Request for Further Information and additional resource consents

Record Number/s: CRC184166, CRC201366, CRC201367, CRC201368
Applicant Name: Bathurst Coal Ltd
Activity Description: Various consents to undertake mining activities at the Canterbury Coal Mine

SUBJECT: Canterbury Coal Mine, Consented Baseline

Figure 1: Proposed mine pits under CRC991437

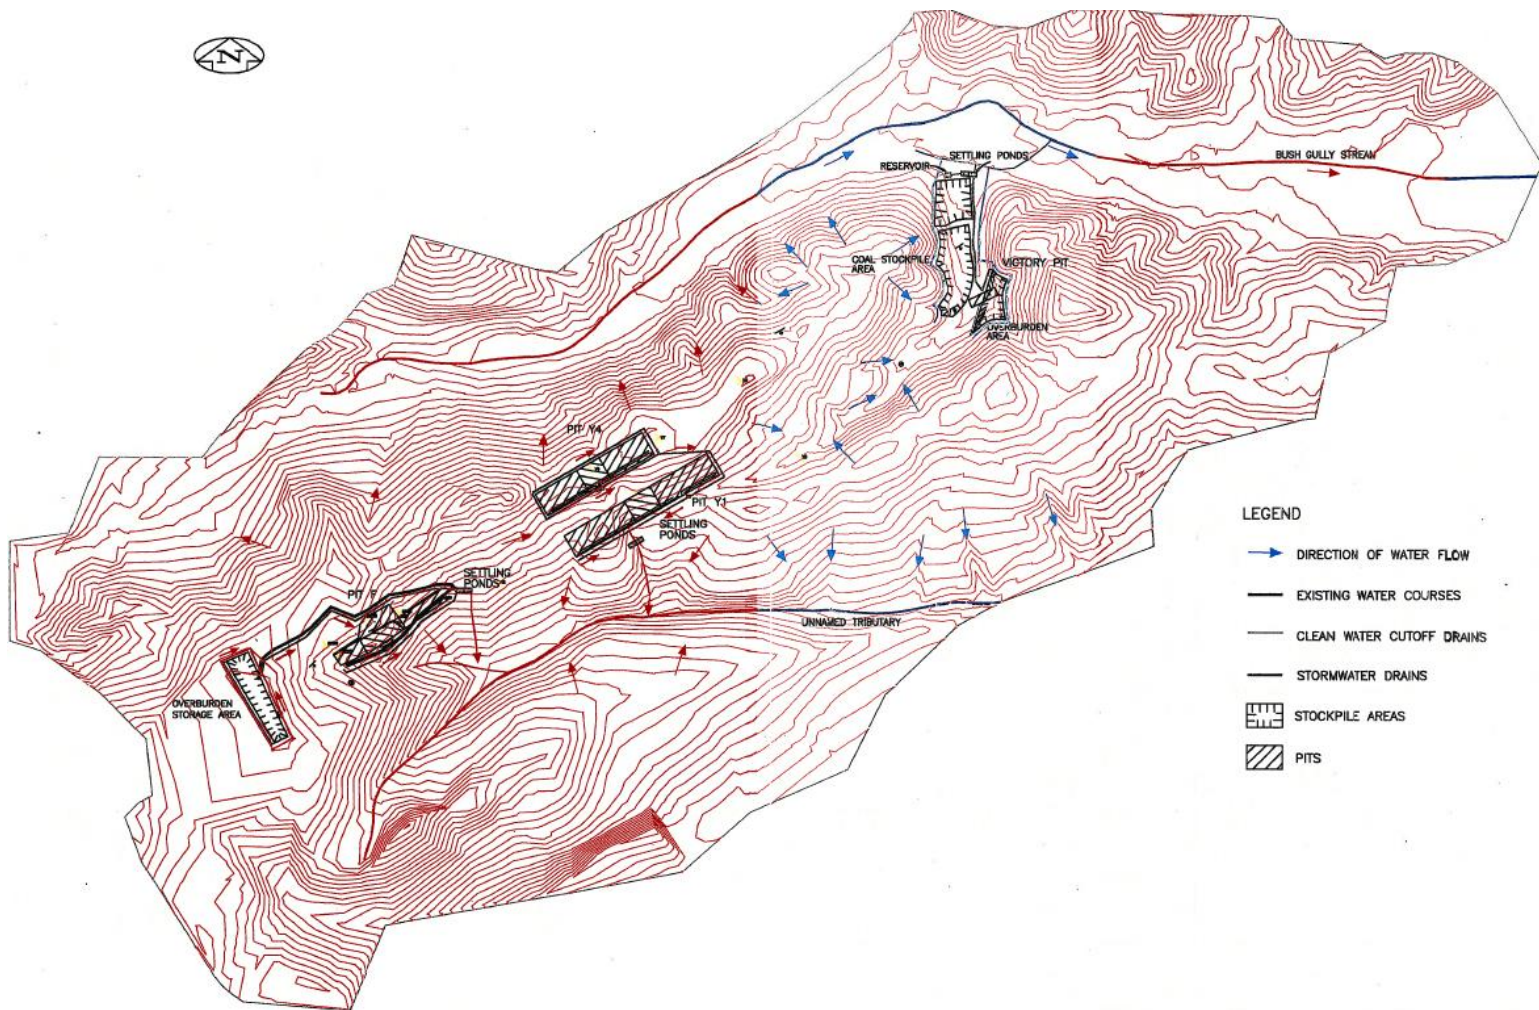
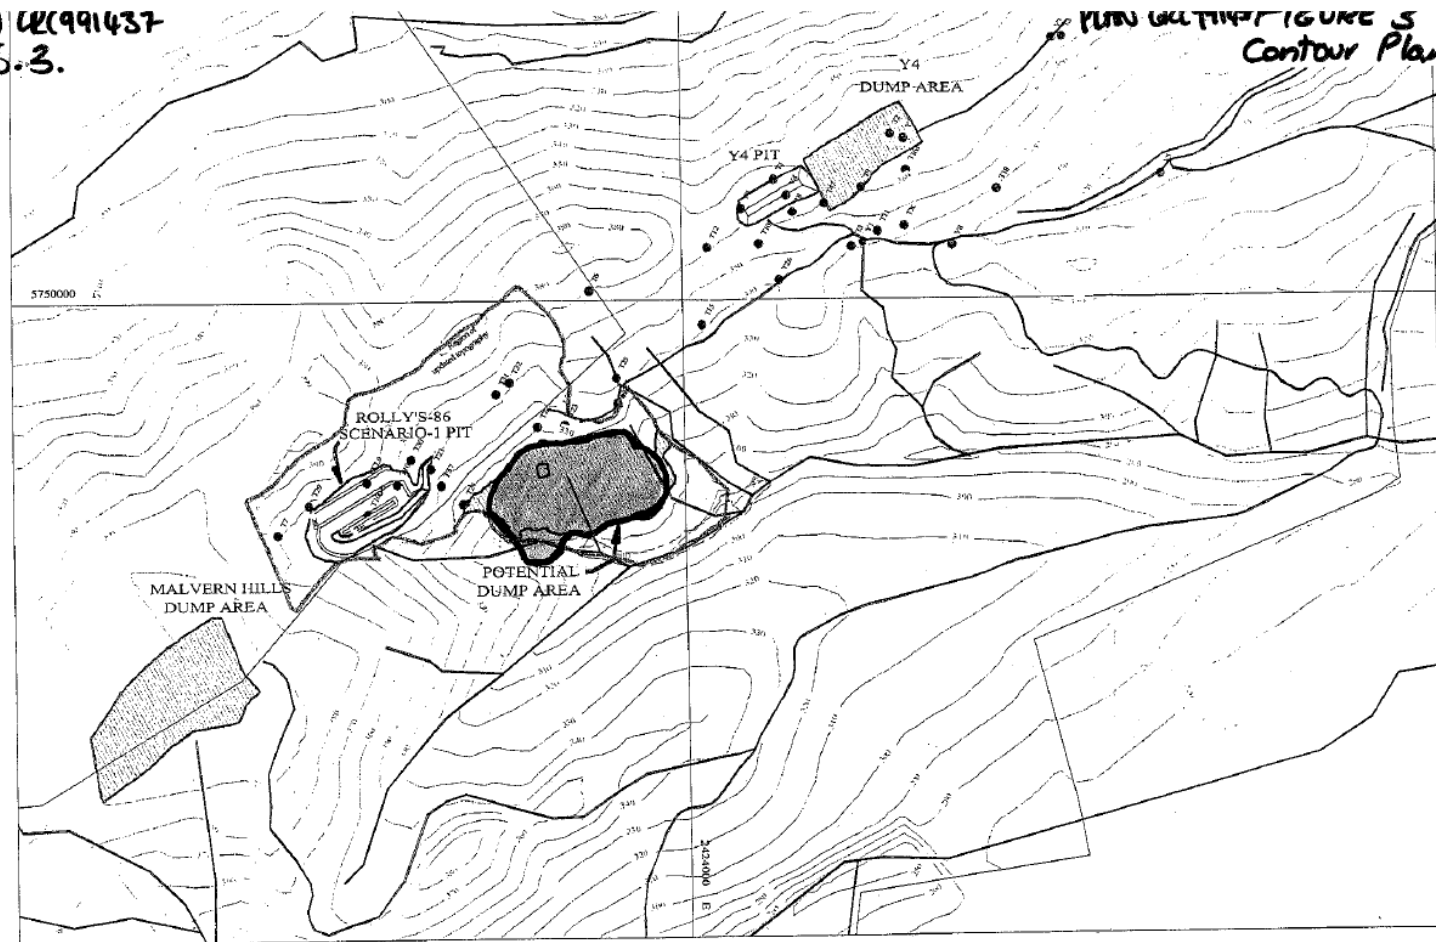
5. The proposed mine pit areas are shown in Figure 1 below. The unnamed tributary identified is the Tara Stream.

Figure 3: Canterbury Coal Mine Staging Plan

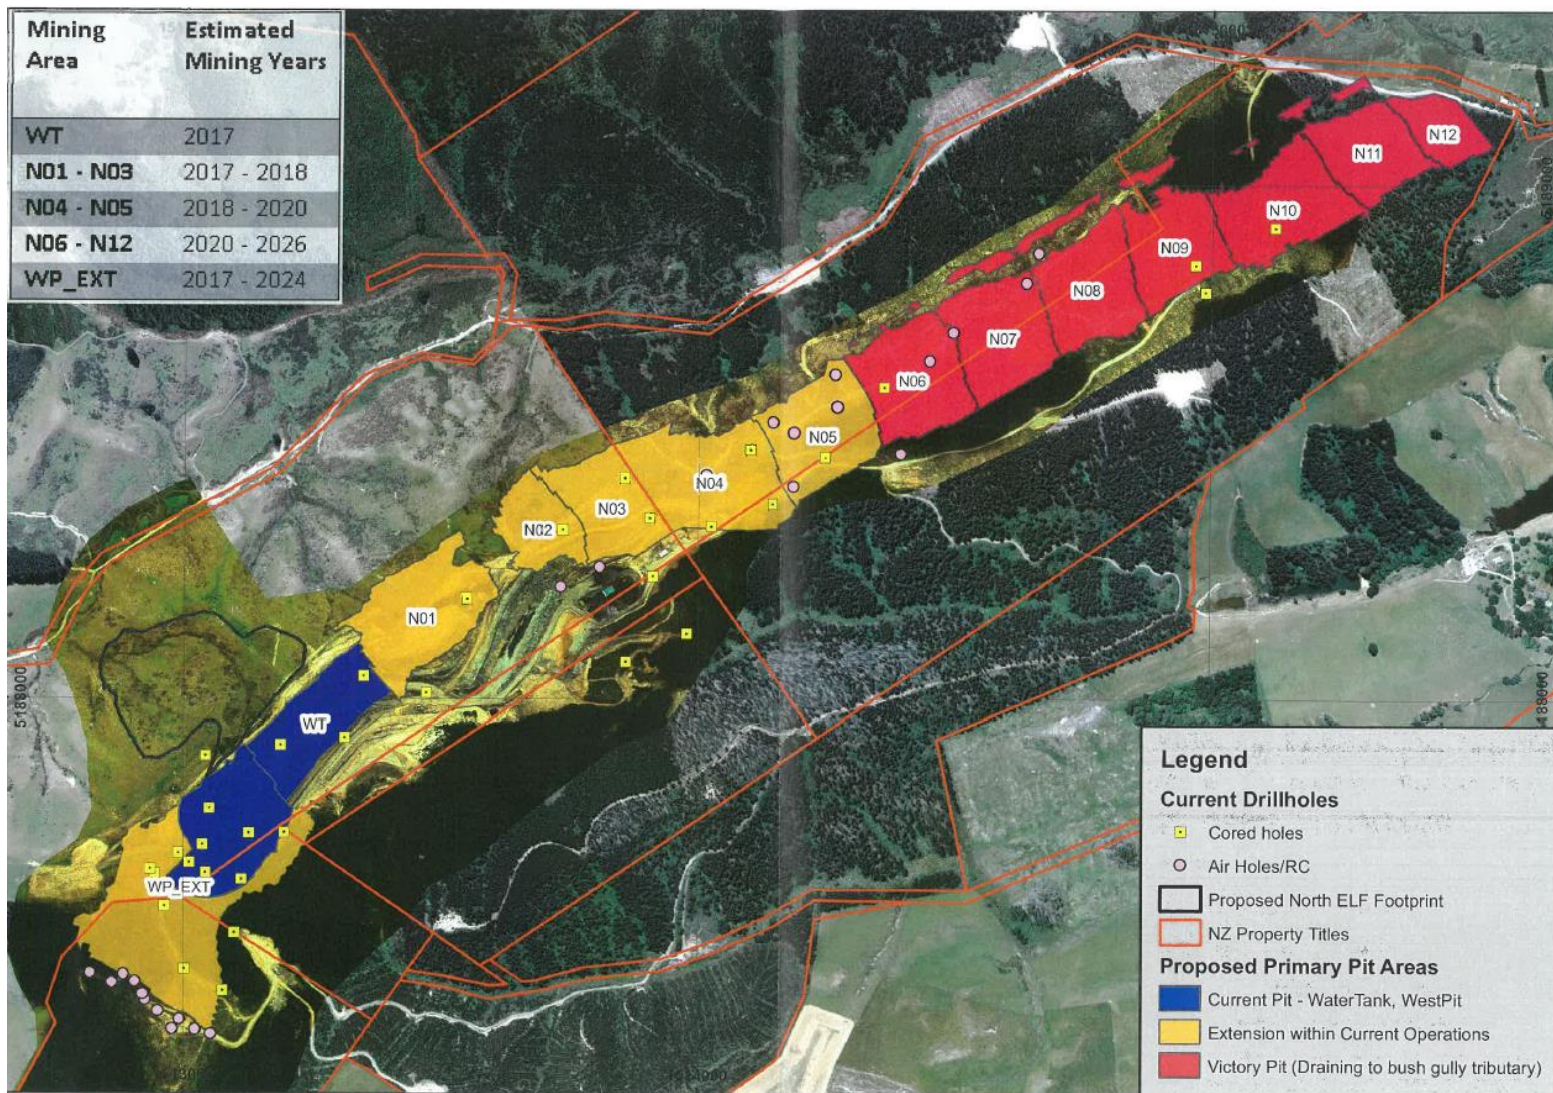
20. Following the granting of CRC170541 the applicant provided a proposed mine staging plan (see Figure 3) and sought pre-application advice for regarding consents necessary to expand the mine.¹⁰

21. A pre-application meeting was held on the 7 June 2017. An email summary of this meeting was sent to Landpro on 8 June 2017 seeking confirmation of the future activities proposed and the advice that was to be provided.¹¹ Importantly, this email summarised the proposed future activities as operations moving to the south and north concurrently from the 'current mining area' into the areas identified as WT/WP_EXT) and NO1-NO5 as shown on the staging plan (see Figure 3).

24. Discharges from the 'current pit' as identified on Figure 3 may also be consented as this was what was being excavated at the time CRC170540 and CRC170541 were lodged. However, as no plan was provided as part of the application, only site visits undertaken at the time informed the consent process therefore this is uncertain. For the purposes of this assessment, this area has been included as part of the consented baseline.

Figure 4: Comparison of Proposed Mine Operations Area and Pit F, Y 1 and Y4

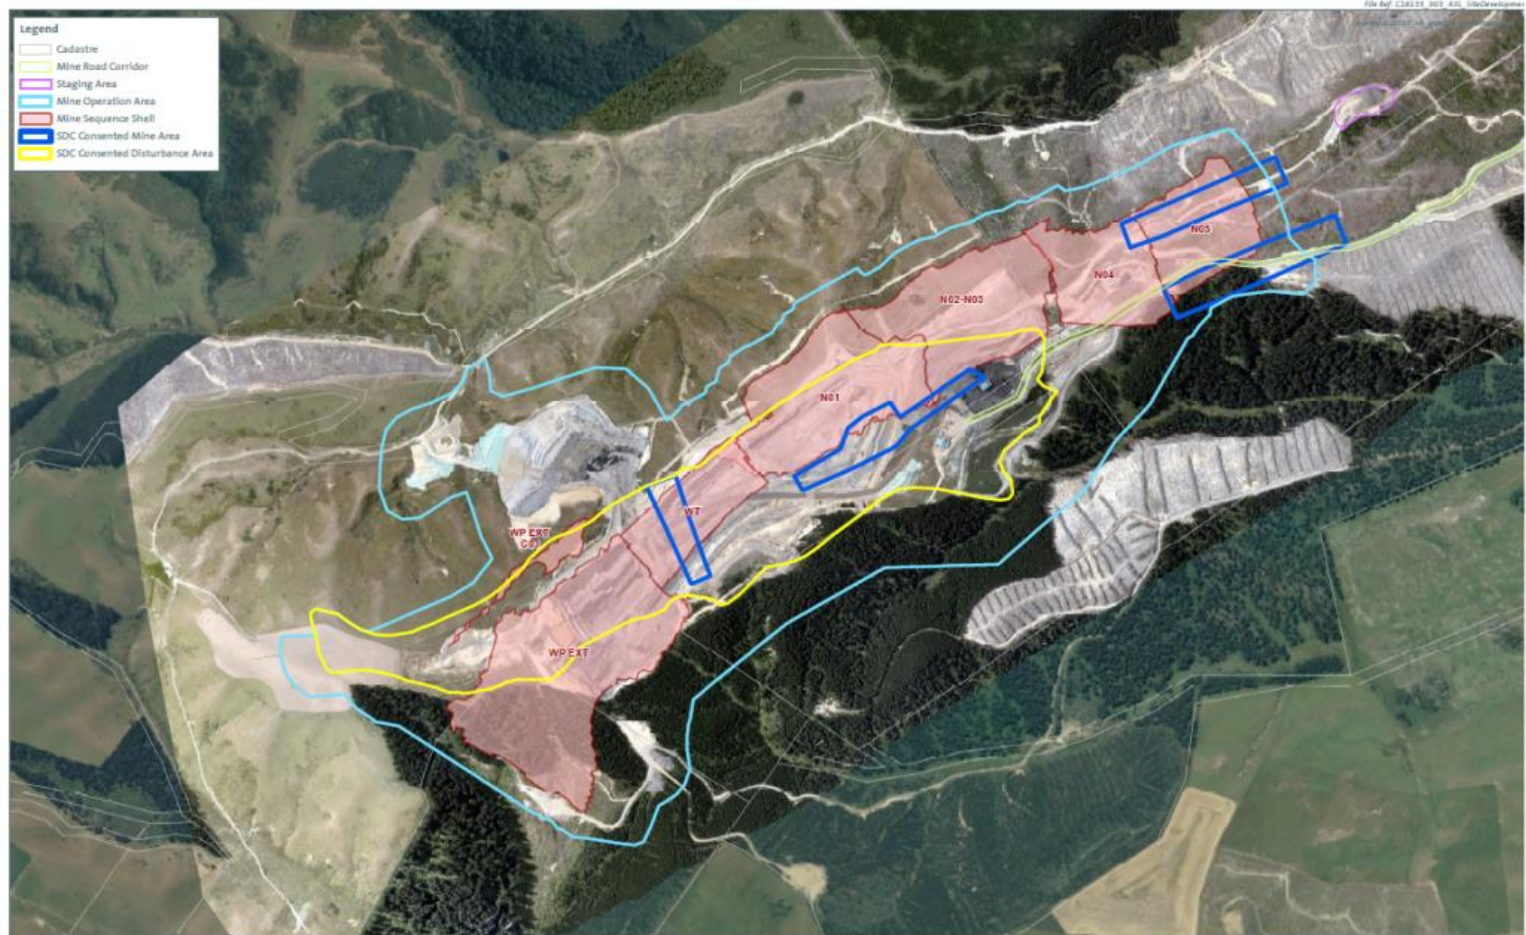
23. It is my view that only discharges from part of N01, N02-N03 extension, N04 and N05 are currently consented. This is on the basis that some of these areas align with Pit F and Pits Y1 and Y4 authorised under CRC991437, CRC991437.1 and CRC151389 (see Figure 4)¹³. This area also partially corresponds with the pit shown on Figure 2 identifying the Rolly's scenario 1 pit which was being excavated in 2008.

¹³ Note that Figure 4 does not show the extension area to N02 and N03 as now included within the proposed Mine Operations Area which would also be partially consented.
